SCHURTER

Parts with rated current from 5A to 10A no longer have a VDC rating. All parts received new cURus approval mark.

Product Change Notification					PCN 172322 Change of rating			
owner	creation date	release date	released by	change order	rev	page	D10-070-491	
schmidre	06.01.2023	06.01.2023	schulejo	2025275	A	1 of 2

1 Products affected

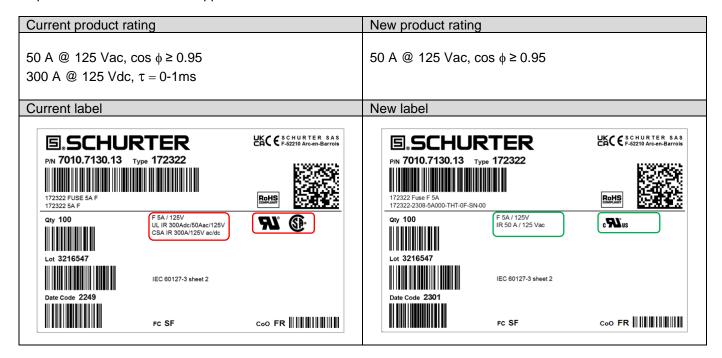
- Change of electrical rating
- Change of approval

Verify, if the Breaking Capacity rating is mandatory in your application
